Development Review Committee (DRC) Meeting

Tuesday, September 19th, 2023 – 9:30 AM

Subject Case # 23-06-FSP-Spincity Laundry

Subject Case # 22-03-PPR-DeBary Town Park

C100

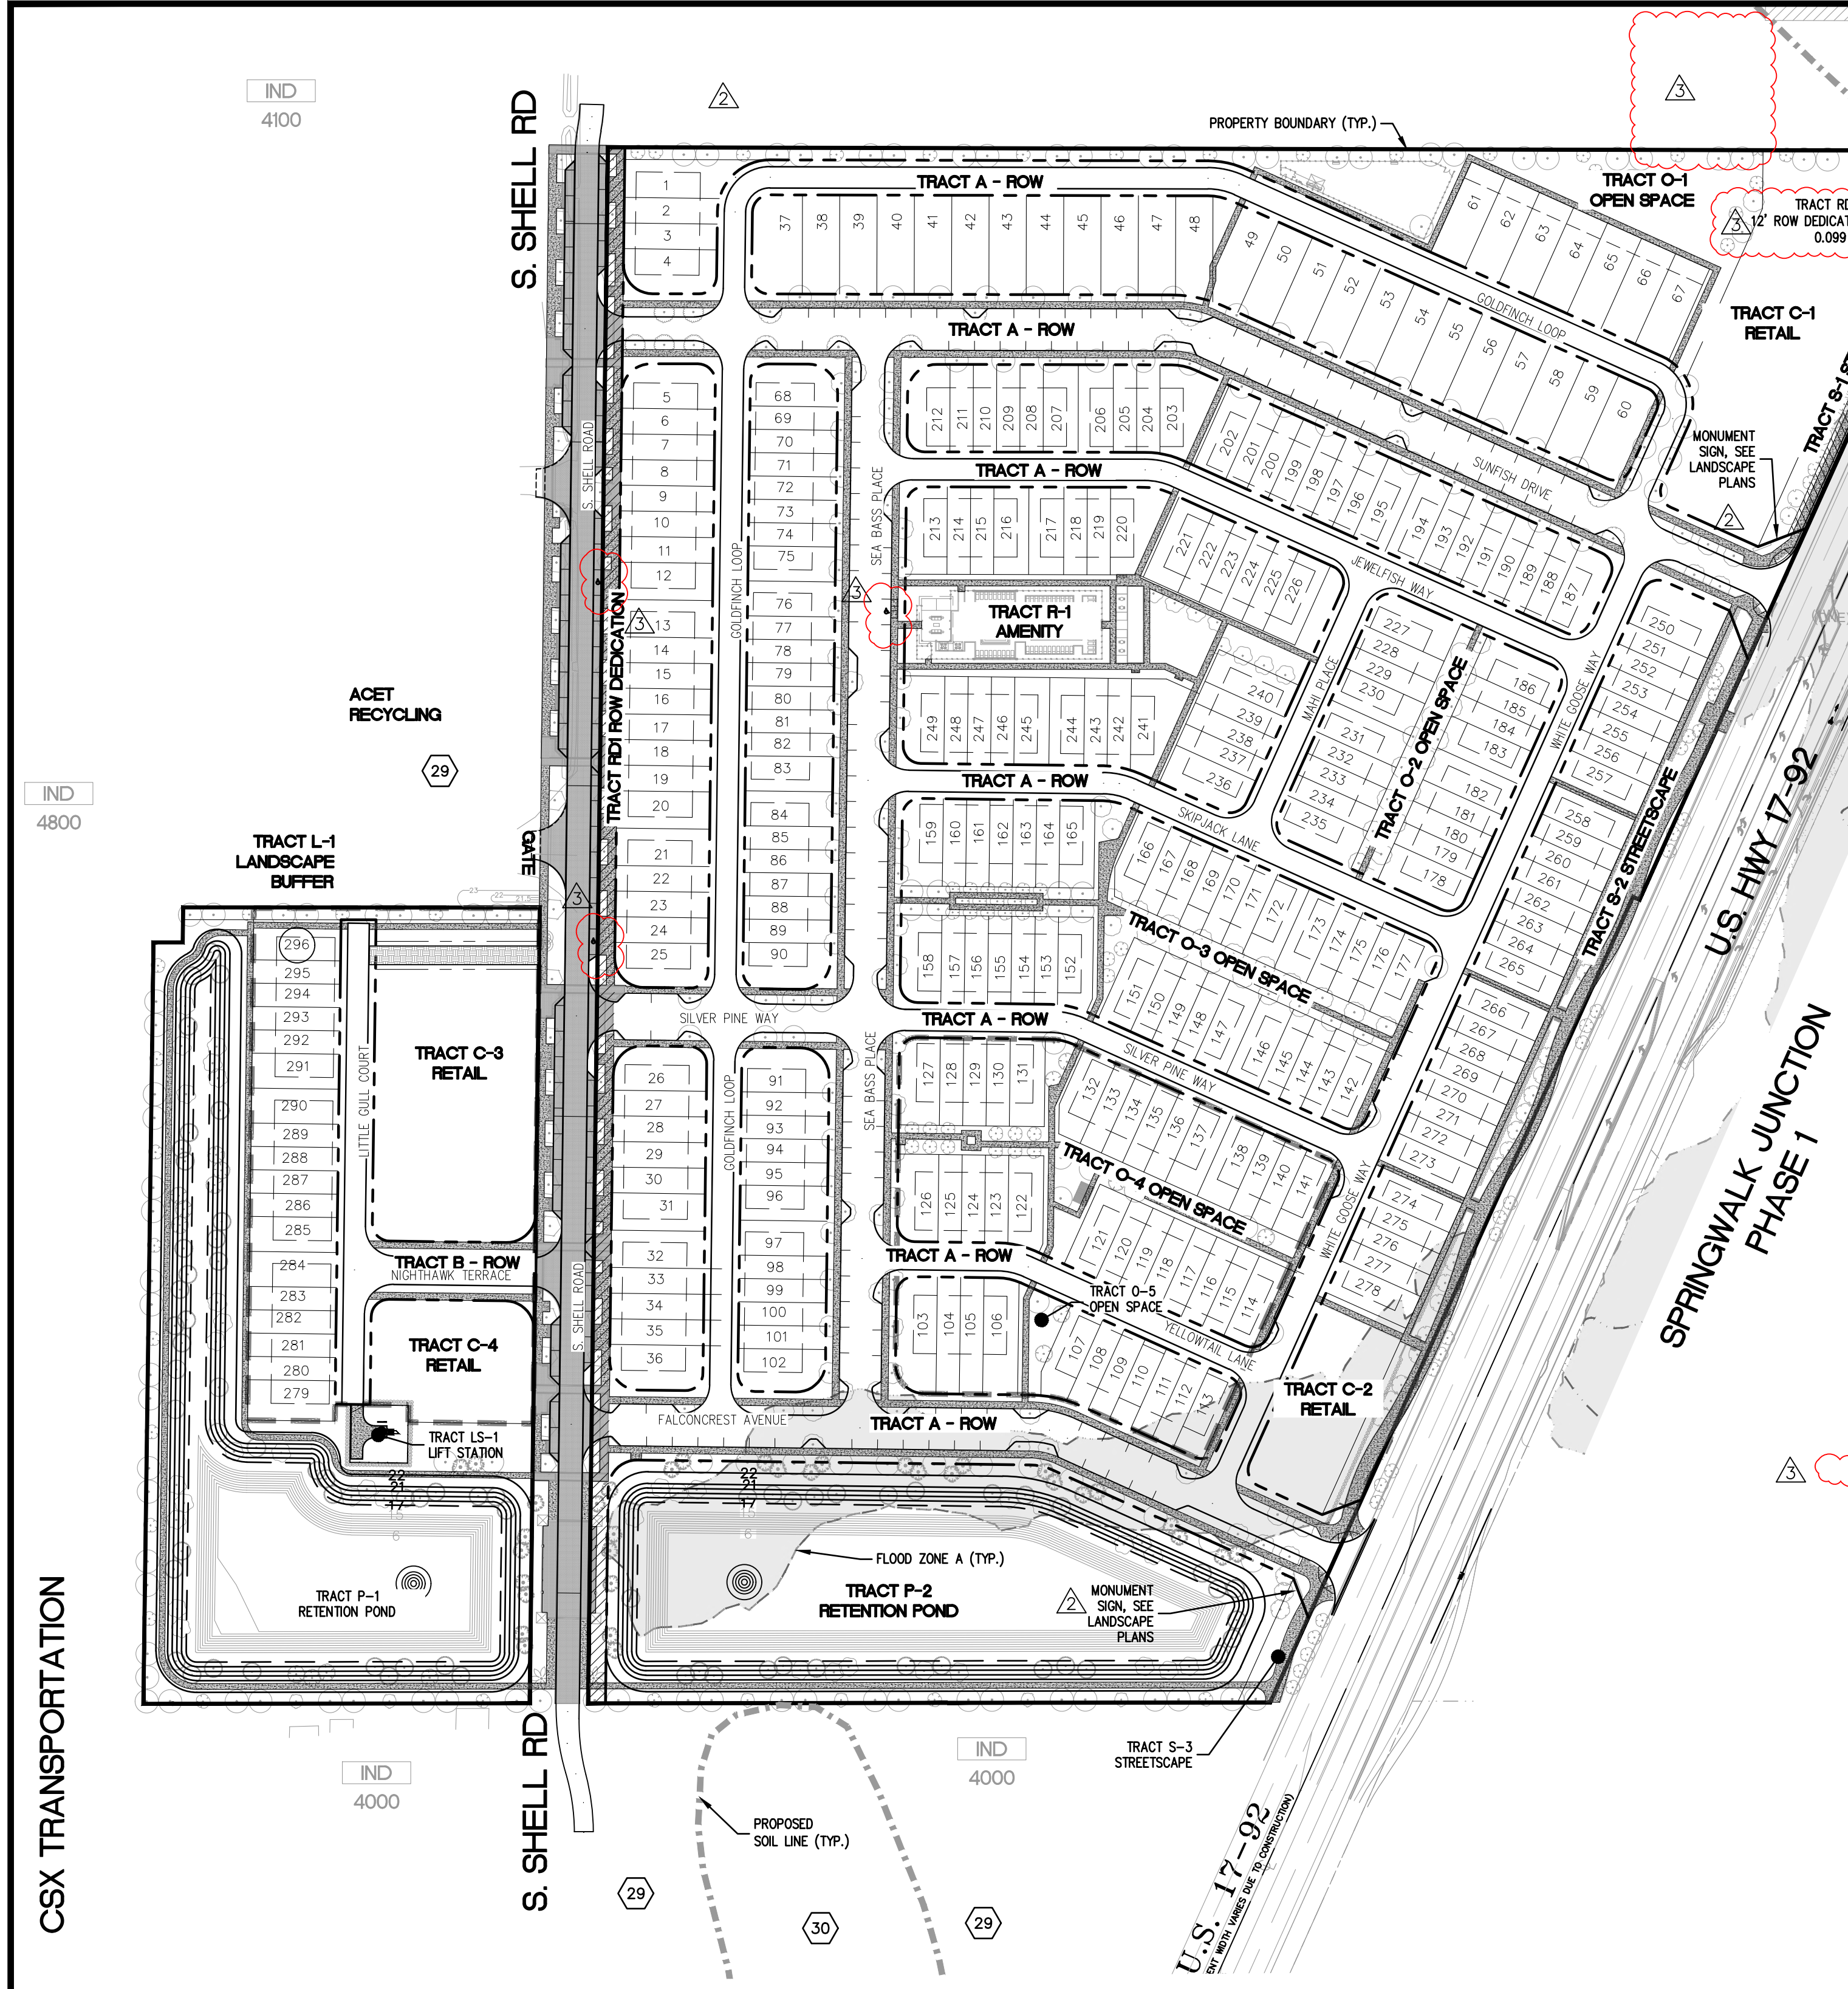
1. Revise waiver Number 3 on Sheet 1 of engineering plan to the newly council approved waiver.
2. C-100 notes mention that project will be built in one phase - project has 2 phases. Please verify.

C101

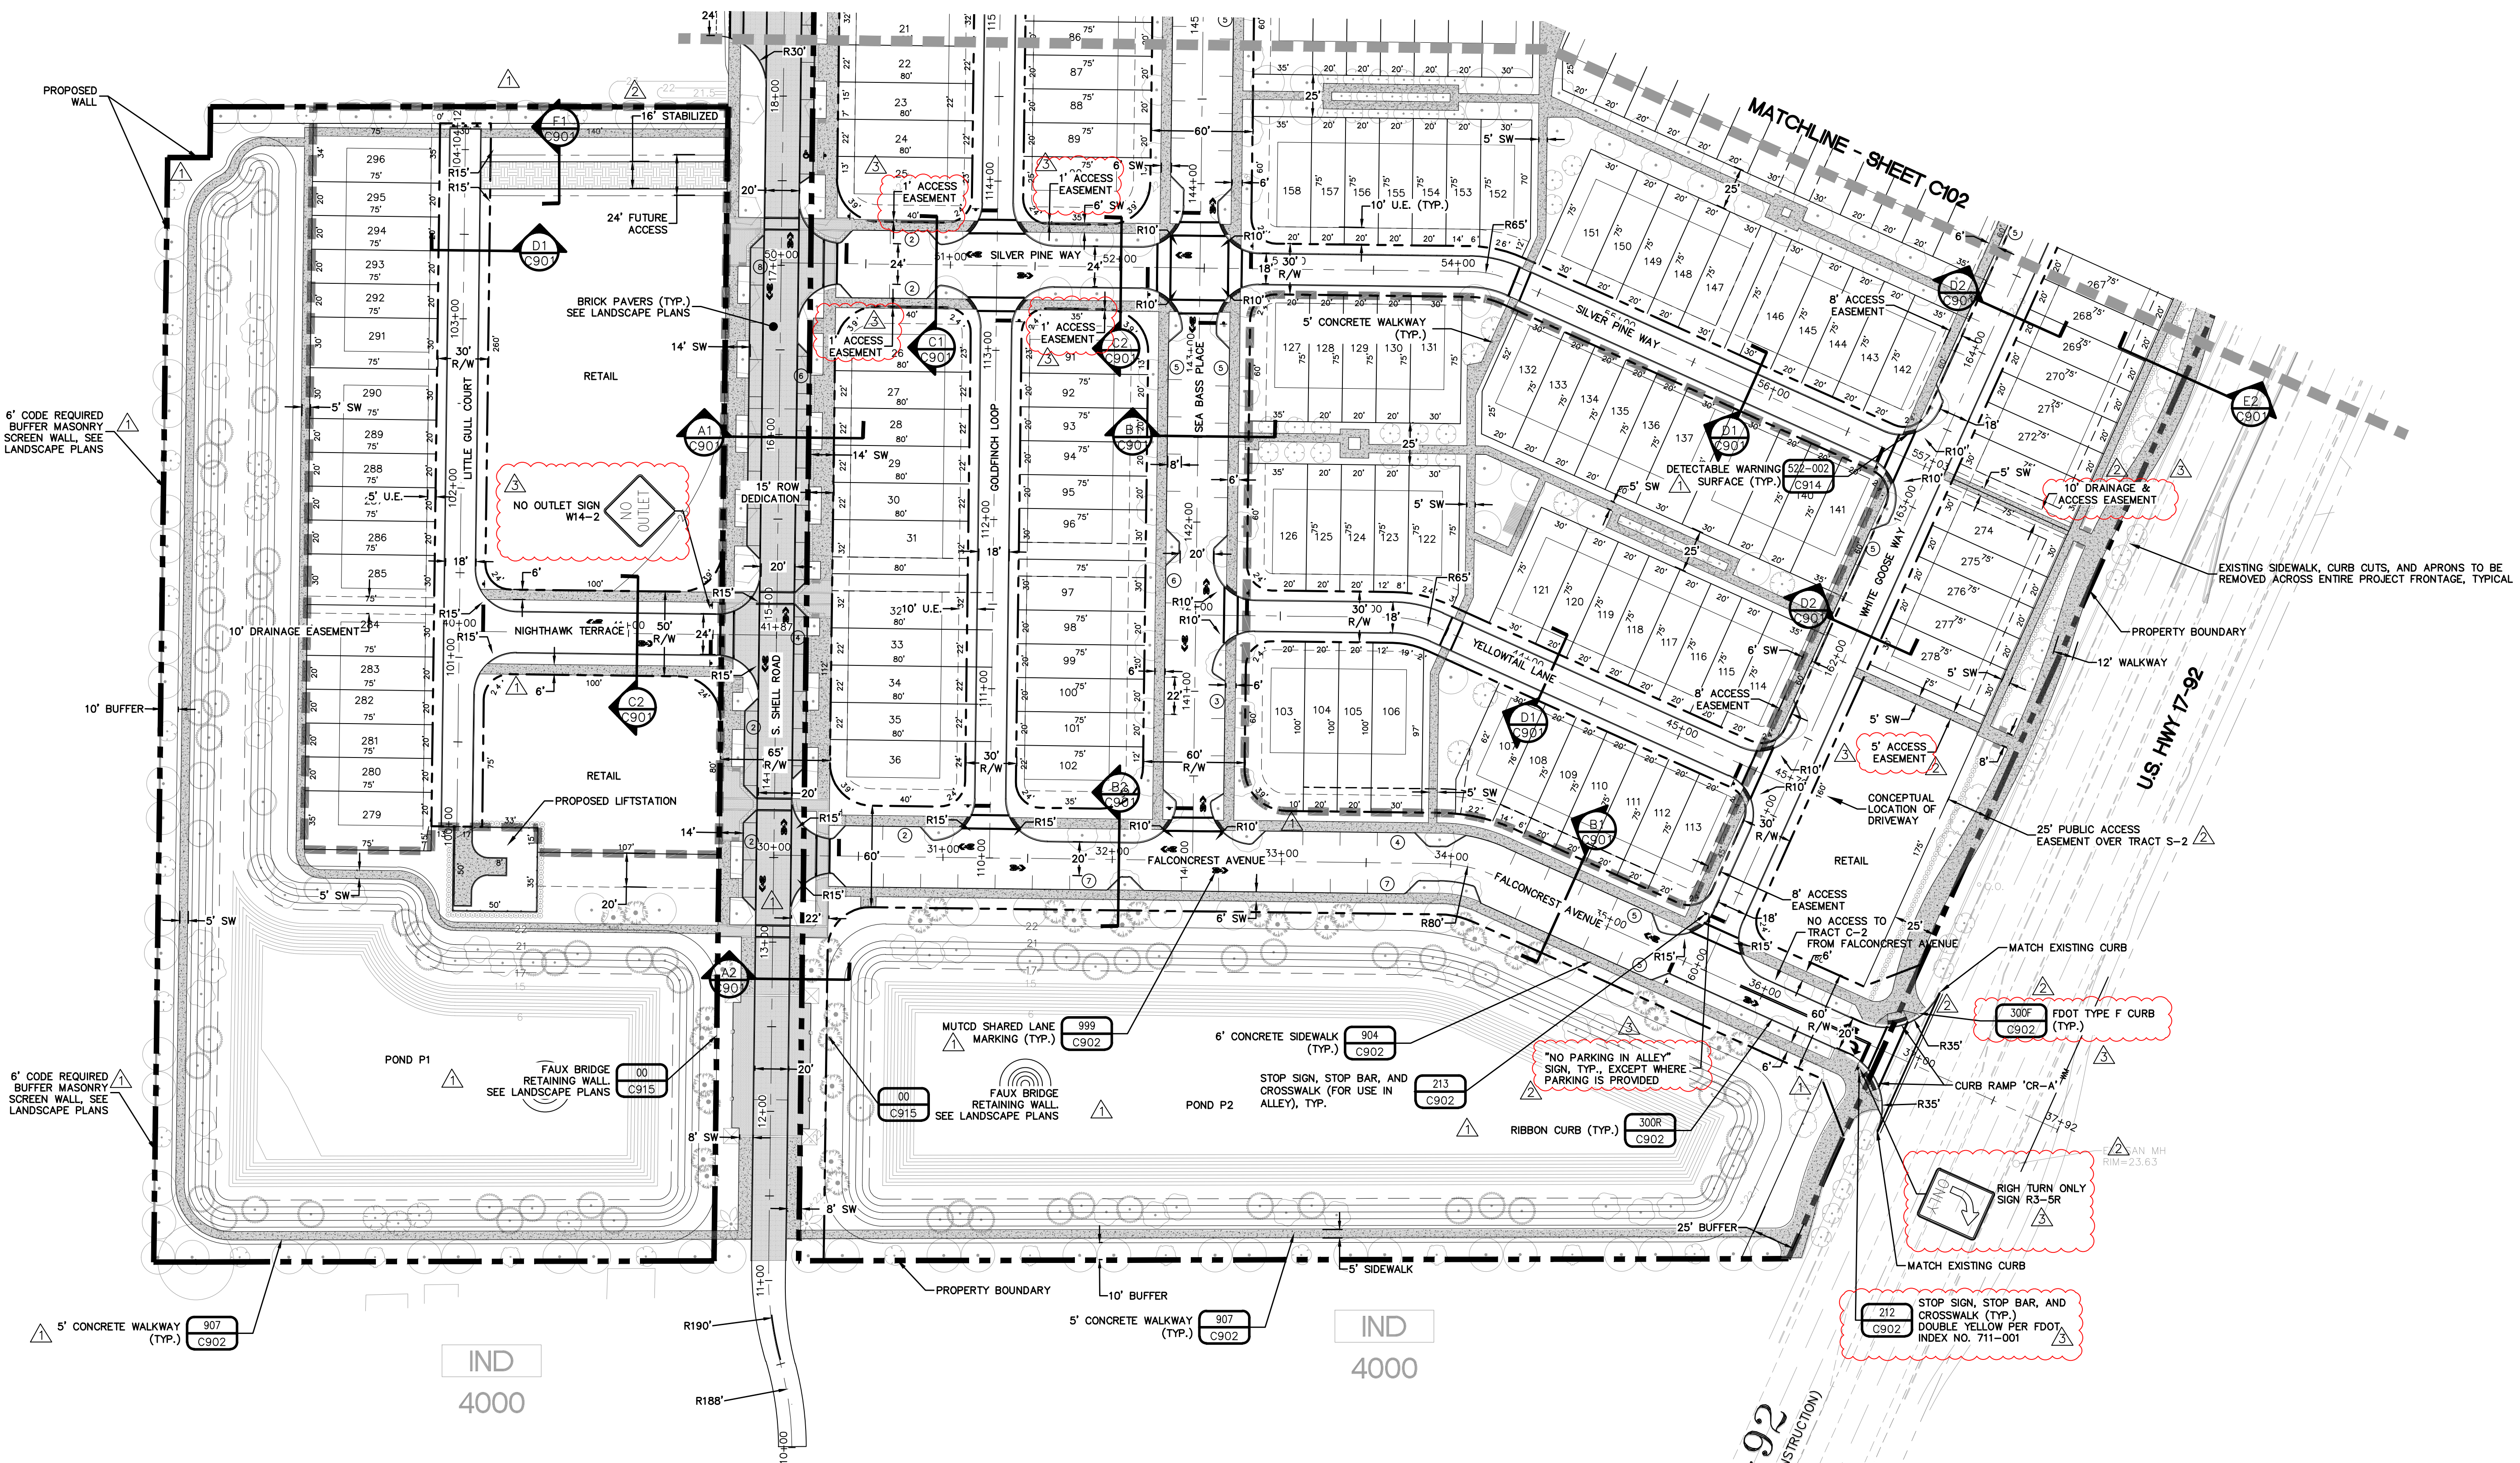
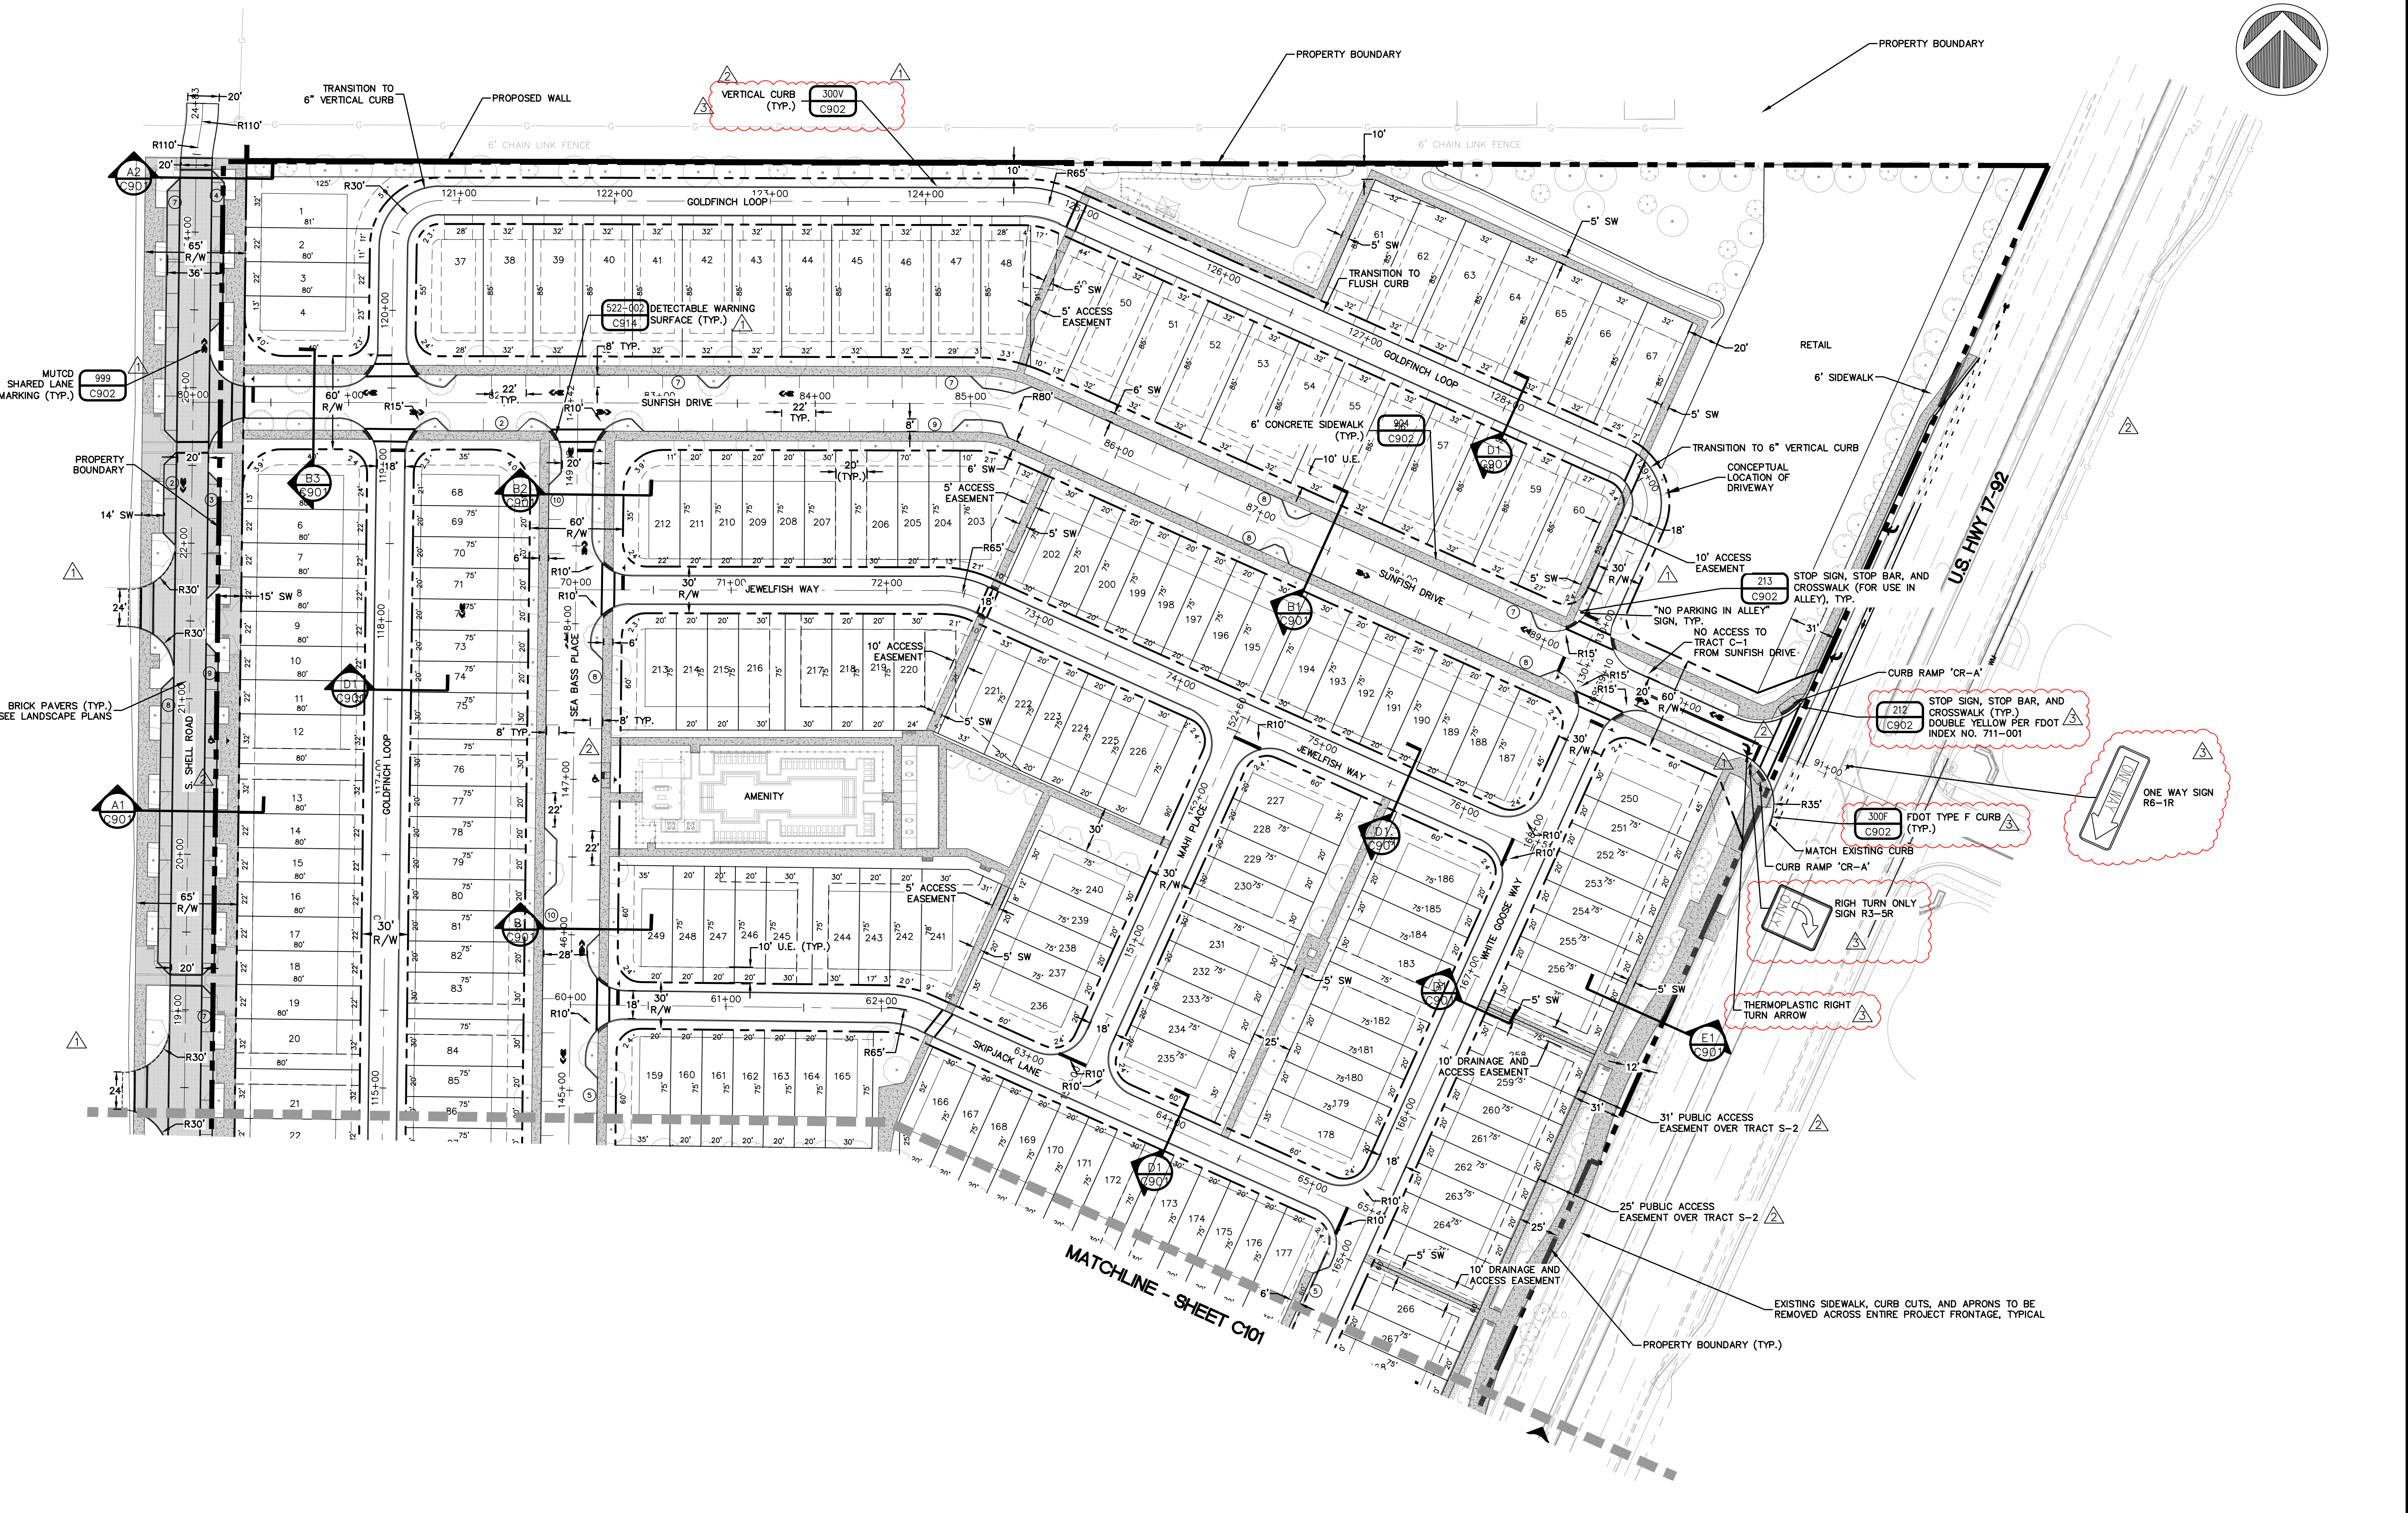
5. Clarify R 15' marked on north west corner of tract C3- Sheet C 101.
6. What is the status of the Bald eagle nest relocation- USFWS Permit?
7. Is monument signage on Signage easement?
